LETTER 164 SCHIMANDLE, JOHN (MARCH 6, 2006)

Figure 3.3-1
Habitat Area map

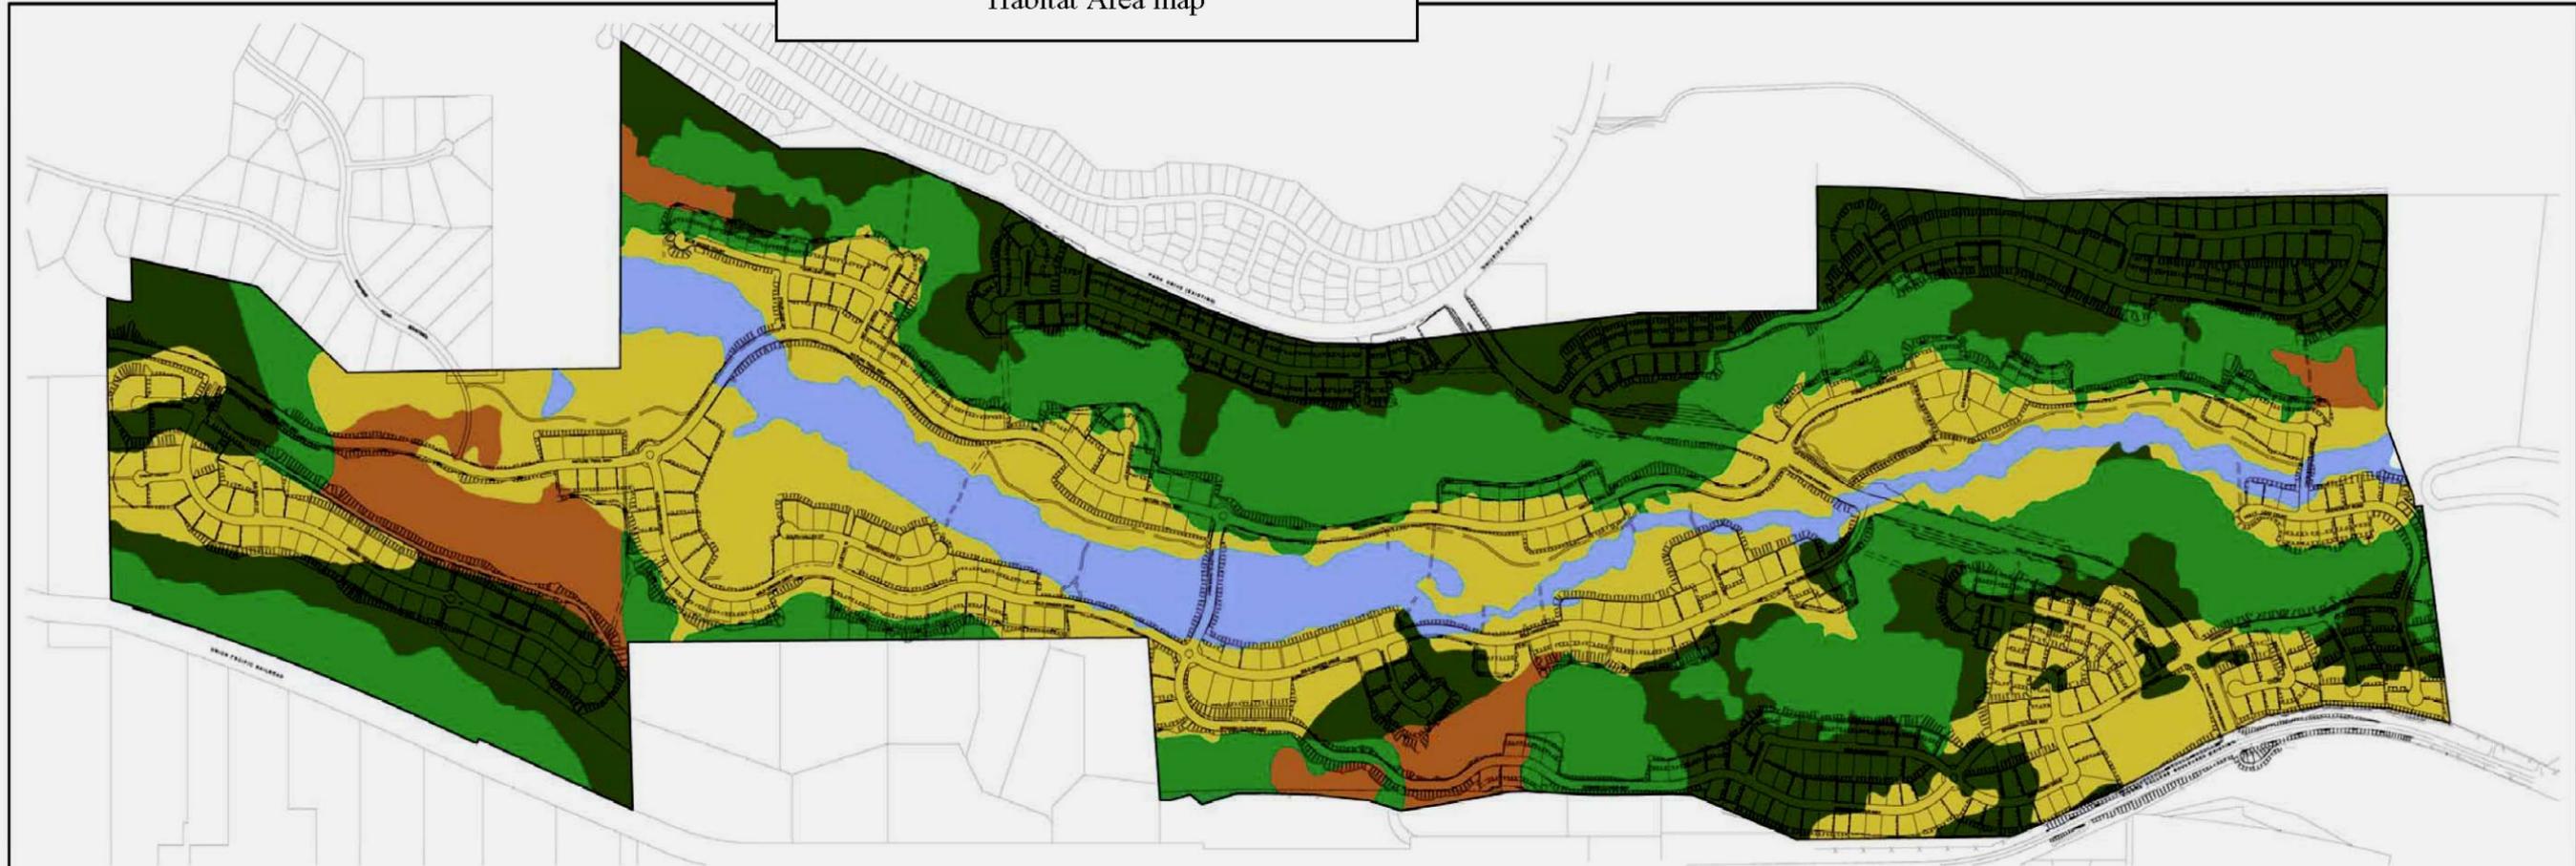
164-100	4.7-8	Paragraph 2	Reference to a "proposed nature reserve" is mentioned here. The location of this nature reserve is never discussed. Please include more specifics about this preserve.	omission
164-101	4.8-1,51	General Comment	Impacts on wildlife due to projected blasting in section 4.9 were not addressed.	omission
164-102	4.8-2	Vegetation	Section is missing 35% of land. This section has four subsections; Grassland, Woodland, Riparian Wetlands and Seasonal Wetlands. The total percentage of these four areas is 65% (30+29+3+3) which leaves 35% unaccounted.	omission

The commenter is correct in that the identified section of the DEIR does not include a comprehensive listing of habitat-types that exist in the project area. The Figure 3.3-1 (habitat

map) indicates that 33 percent (205 acres) of the 622-acre project area is covered by grasslands, 5 percent (33 acres) by oak woodlands, 27 percent by foothill mixed woodlands (169 acres), 27 percent (166 acres) by oak savannah, and 8 percent (50 acres) by riparian hardwoods. A total of 3 percent (22 acres) of the project area (generally within annual grassland habitat) has been identified as seasonal wetlands.

The proposed project will result in the loss of exactly one half (321 acres) of this existing natural habitat, including: 144 acres (70 percent) of existing grassland habitat, 9 acres (27 percent) of existing oak woodland, 48 acres (28 percent) of existing foothill woodland, 112 acres (67 percent) of existing oak savannah, and 7 acres (14 percent) of existing riparian hardwood habitat. Conversely, the project will preserve 61 acres (30 percent) of grassland habitat, 24 (73 percent) acres of oak woodland, 121 acres (72 percent) of foothill woodland, 53 (32 percent) acres of oak savannah, and 43 acres (86 percent) of riparian hardwood habitat.
